# Access Compliance Report

## Public Rights-of-Way

### (Pedestrian Signals)

Intersection ID: N/A	Main Street:	Cross Street: N/A	Location: N/A
ADA ID: D80EB68A5AA0	Signal Type: Two Push Buttons-Non APS	Overall Compliance: No	Severity Score: BTN 1:N/A BTN 2: N/A No BTN: N/A
Codes/Mitigation Info/Possible Solution		Field Measurements/Component Compliance

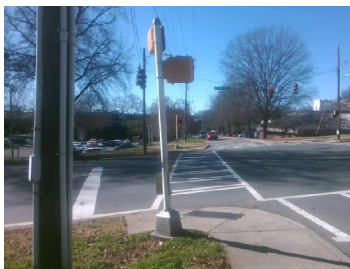
PROW/ADA: TMUTCD 4e.08, R404.2, R406.2, R404.1, R404.7.3

N/A	B 1 FWD Approach Width (in)	N/A	N/A	B 2 FWD Approach Width (in)	N/A
N/A	B 1 FWD Approach Obstruction?	Yes	N/A	B 2 FWD Approach Obstruction?	N/A
N/A	B 1 FWD Approach Obstruction Dist (in)	2.0	N/A	B 2 FWD Approach ObstructionDist (in)	N/A
N/A	B 1 PARA Approach?	Yes	N/A	B 2 PARA Approach?	Yes
N/A	B 1 PARA Approach Constrained?	No	N/A	B 2 PARA Approach Constrained?	No
Yes	B 1 PARA Approach Reach (in)	7.0	No	B 2 PARA Approach Reach (in)	11.0
N/A	B 1 PARA Approach Width (in)	N/A	N/A	B 2 PARA Approach Width (in)	N/A
N/A	B 1 PARA Approach Obstruction?	Yes	N/A	B 2 PARA Approach Obstruction?	Yes
N/A	B 1 PARA Approach Obstruction Dist (in)	2.0	N/A	B 2 PARA Approach ObstructionDist (in)	3.0
Yes	B 1 Clear Floor Space Slope (%)	1.9	N/A	B 2 Clear Floor Space Slope (%)	14.3
No	B 1 Clear Floor Space XSlope (%)	7.4	N/A	B 2 Clear Floor Space XSlope (%)	0.4
N/A	B 1 PAR Slope (%)	1.0	N/A	B 2 PAR Slope (%)	12.9
Yes	B 1 Height (in)	45.0	Yes	B 2 Height (in)	44.0

Yes	B 1 Clear Xing Direction?	ClearlyMarked	Yes	B 2 Clear Xing Direction?	ClearlyMarked
	B 1 Crossing Direction	To NW		B 2 Crossing Direction	To SW
Yes	B 1 DistanceTo XWalk (in)	0.0	Yes	B 2 DistanceTo XWalk (in)	0.0
No	B 1 DistanceTo Curb (in)	79.0	No	B 2 DistanceTo Curb (in)	79.0
Yes	B 1 Diameter (in)	2.0	Yes	B 2 Diameter (in)	2.0

Possible Solutions: Replace Signal Push Button With APS Button on New Post. Remove & Relocate Sign.
